ORIGINATION FORM

Proposed Revisions to a Standard Plans Index

Index Number: 455-031

Index Title: 30" SQUARE PRESTRESSED CONCRETE PILE -
HIGH MOMENT CAPACITY

LAST REVISION 11/01/22	DESCRIPTION:		FY 2023-24 STANDARD PLANS	30" SQUARE PRESTRESSED CONCRETE PILE - HIGH MOMENT CAPACITY	INDEX	SHEET
					455-031	1 of 1

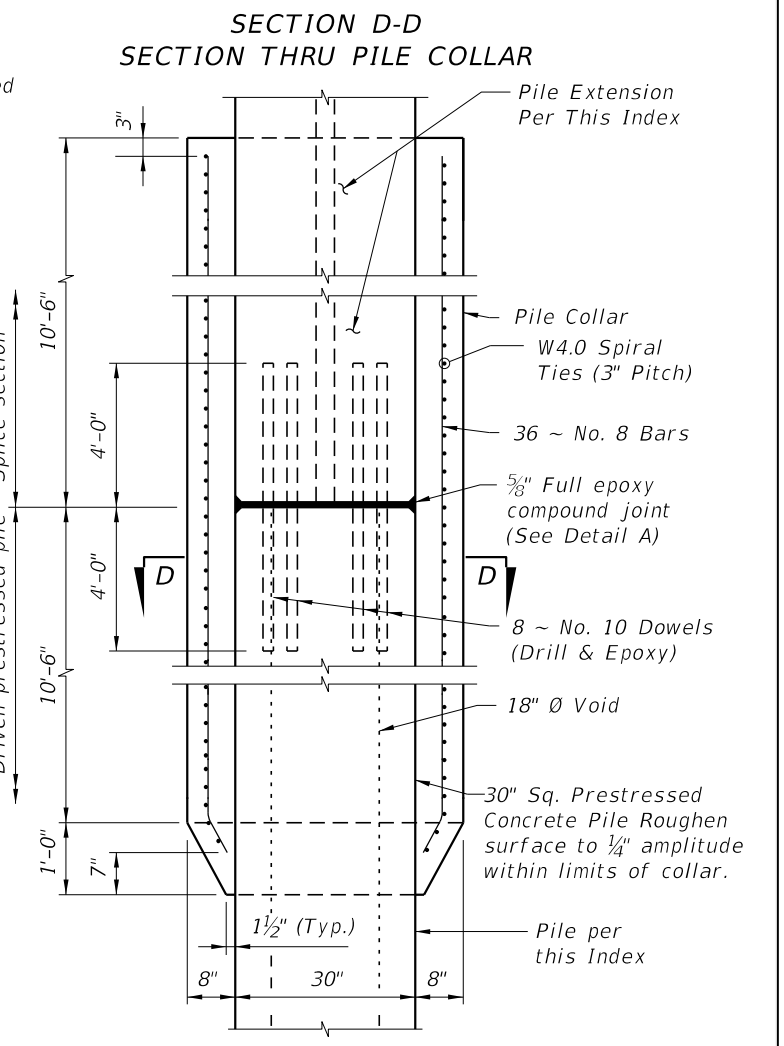
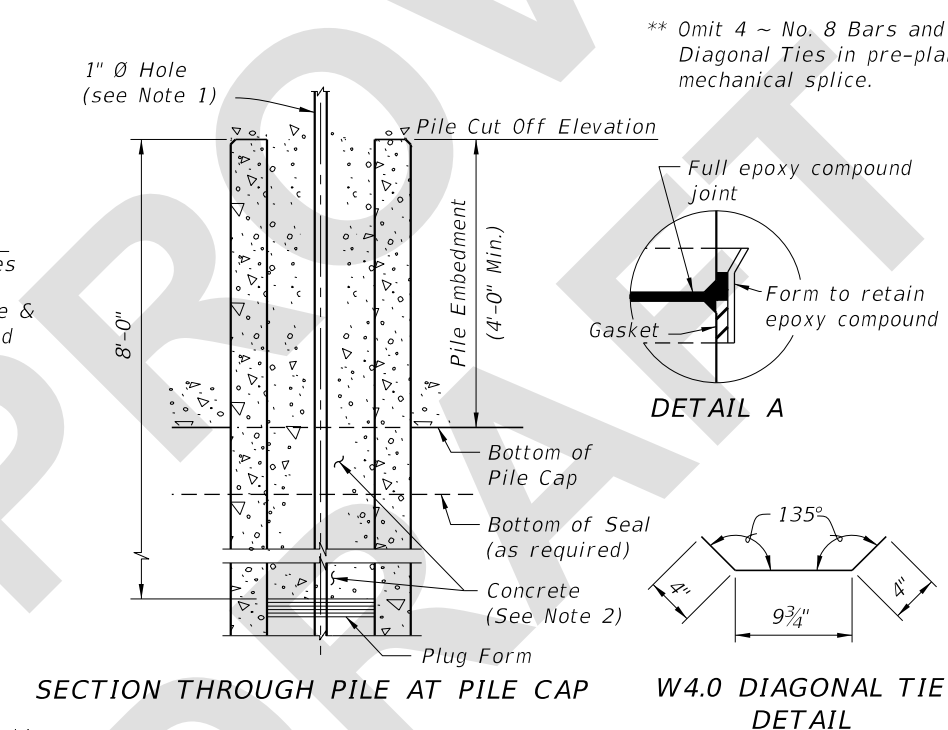
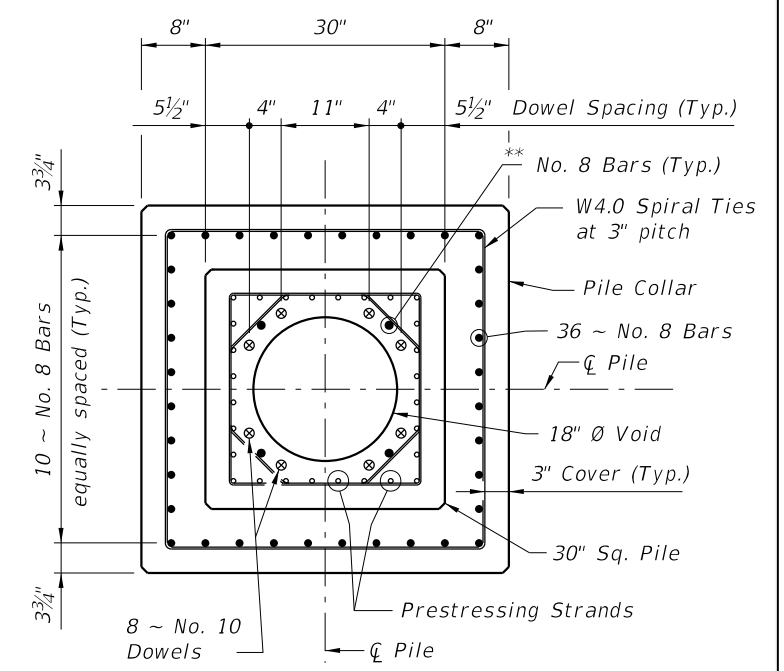
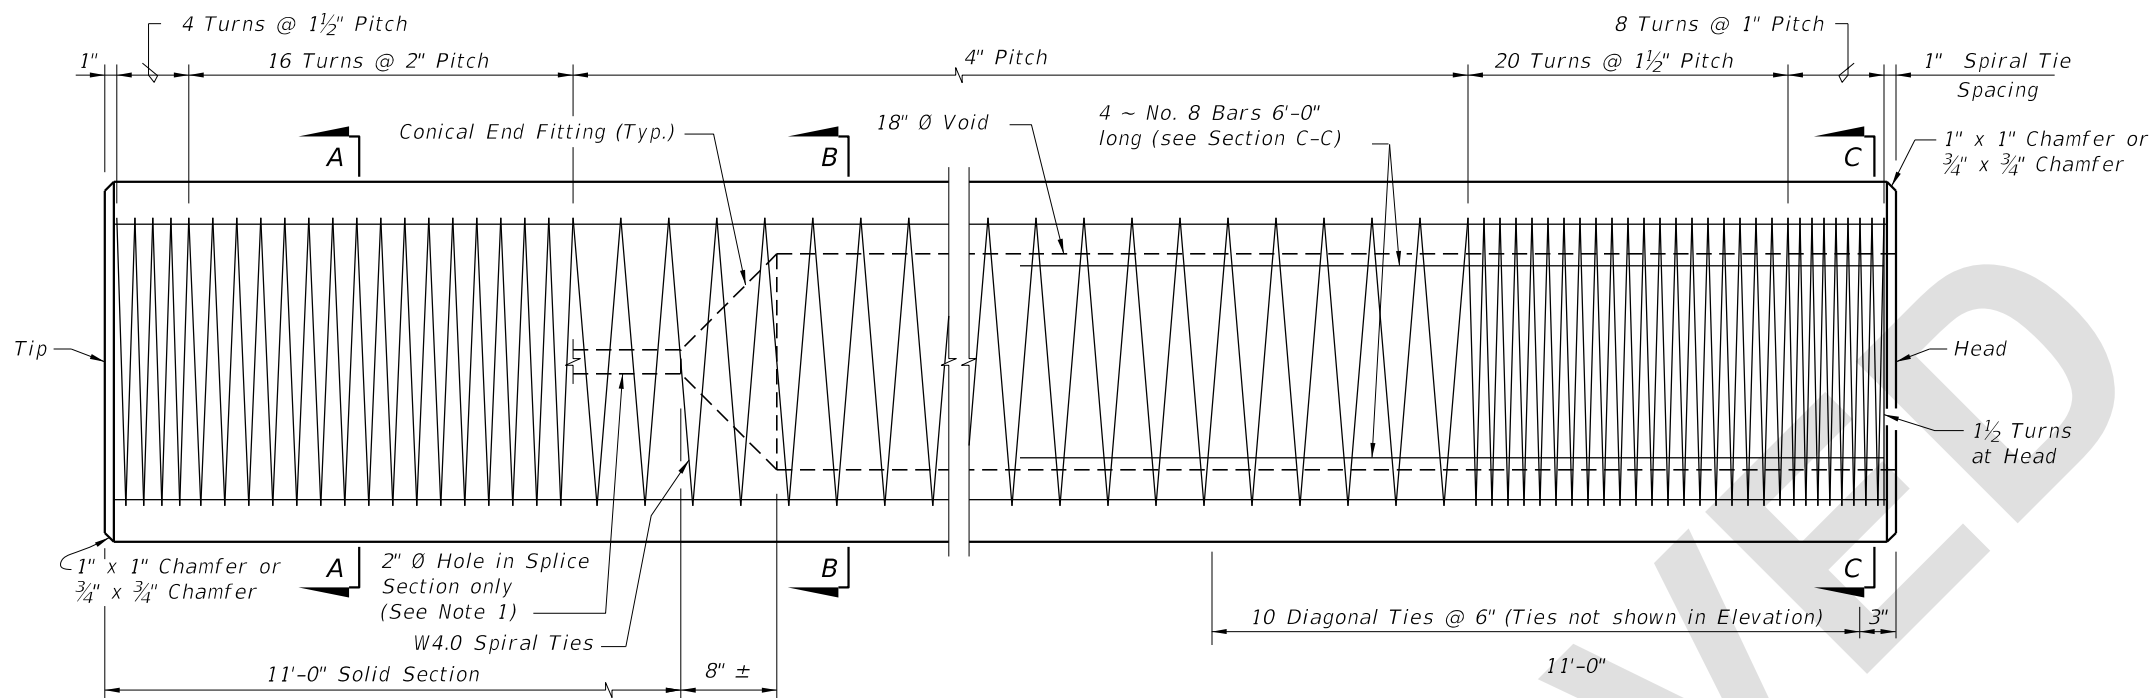
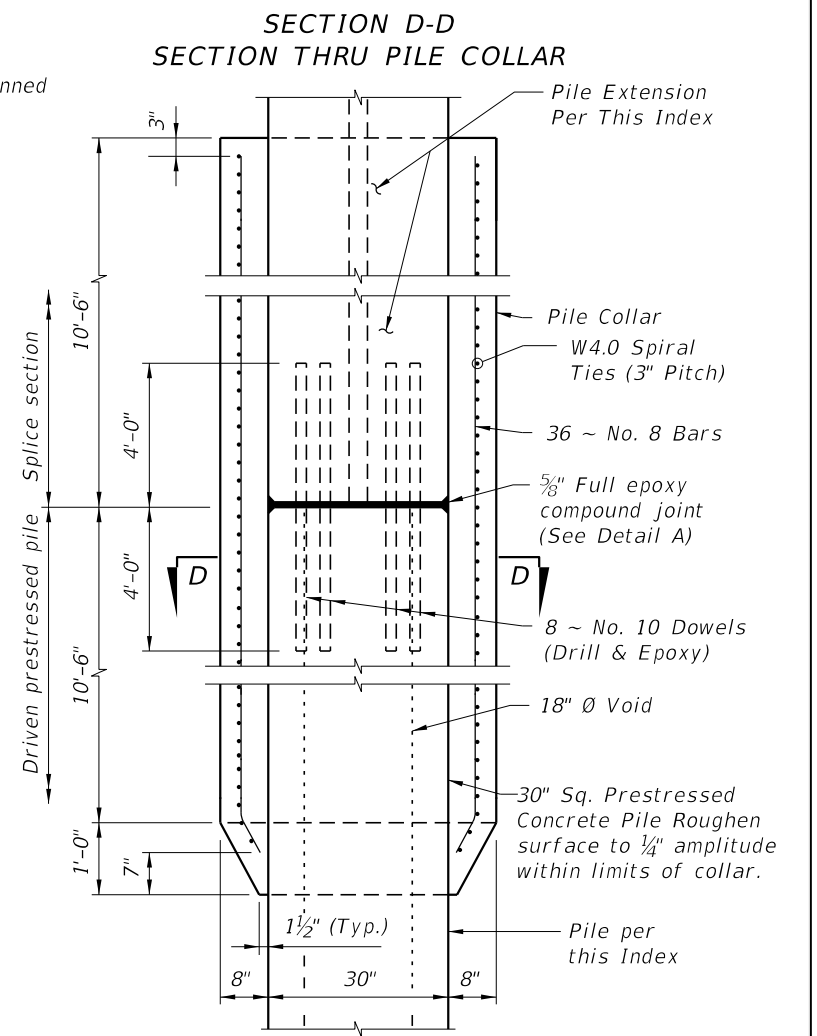
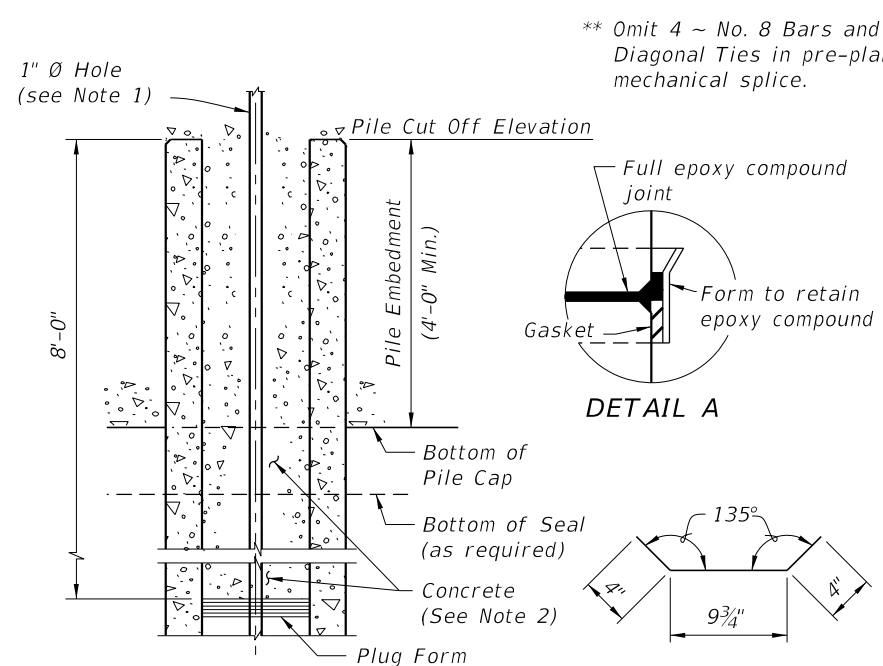
Reverted to the previous version of the Standard.
